1. **Title:** Cyber Security — BES Cyber System Categorization
2. **Number:** CIP-002-~~5.1a6~~
3. **Purpose:** To identify and categorize BES Cyber Systems and their associated BES Cyber Assets for the application of cyber security requirements commensurate with the adverse impact that loss, compromise, or misuse of those BES Cyber Systems could have on the reliable operation of the BES. Identification and categorization of BES Cyber Systems support appropriate protection against compromises that could lead to misoperation or instability in the BES.

See implementation plan for CIP-002-6.

Criterion 2.12 Examples:

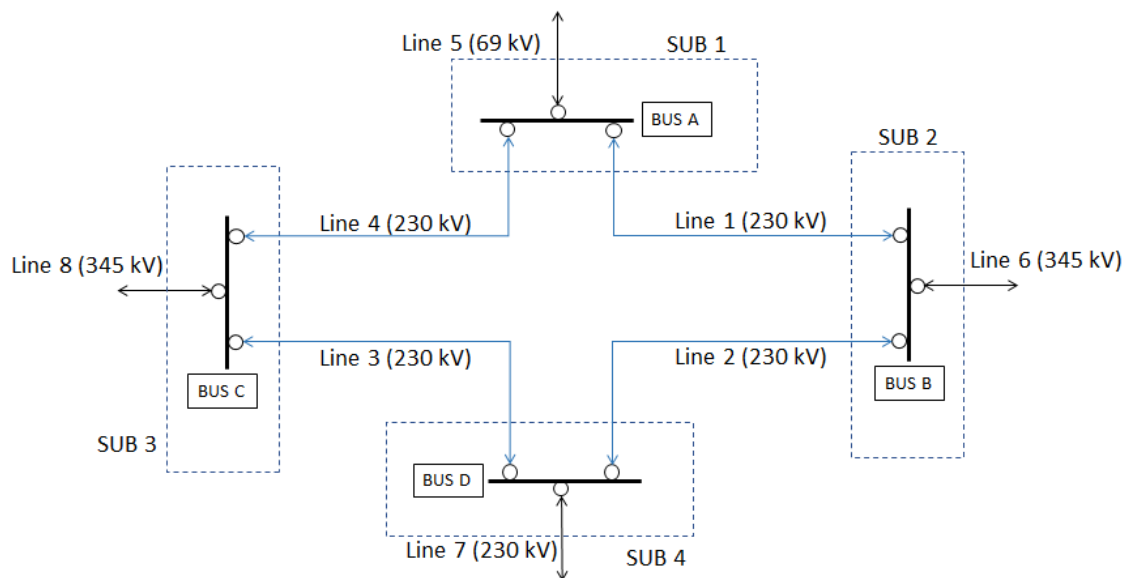
- All BES Transmission Lines that are energized at voltages between 100 kV and 499 kV and are monitored and controlled by a Control Center, including associated data center(s).
- All BES Transmission Lines, including those that connect to neighboring entities, that are monitored and controlled by the Responsible Entity’s Control Center, including associated data center(s).
- Multiple-point (or multiple-tap) lines are considered to contribute a single weight value per line.

In example 1 below, a BES Cyber System is associated with a Control Center that monitors and controls eight BES Transmission Lines. In order to calculate the Control Center’s aggregate weighted value, the Responsible Entity should reference the table located in Criterion 2.12 and sum the weighted values for each BES Transmission Line.

$$\underline{700+700+700+700+700+1300+1300 = 6100}$$
